## **Board of Architectural Review**

SUBJECT: Public Hearing recommendation to City Council: Breezeway, Garden Apartments,

and single-family homes - site redevelopment

1. Case Number: BAR-21-00532

### MDP Submission:

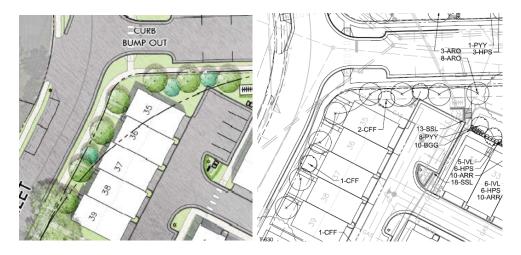
• The Applicant is showing different height measurements for the Certificate plan and the MDP plan, but neither are correct. Previous submissions incorrectly measured height from the floor level of the first floor and not average grade, with a height of approximately 49 feet for the multifamily units and 38 feet for the townhomes. The MDP height exhibit was updated to show the height being measured from the average grade plan, but the height still shows 49 feet for the multifamily units and 38 feet for the townhomes, which does not account for the now lower point of measurement. The Certificate plan was not updated at all. The Planned Development rezoning MDP prescribes the height for the development, the height is required to be shown now and not at the time of building permit. The applicants response, "Detailed height measurements for each lot will be provided at the time of site plan and building permit."

- 4. The plans shall be changed to show correct building heights.
- 5. The doors for two-over-two units must be shown on the plans.
- 6. The mailbox and fence locations must be shown.
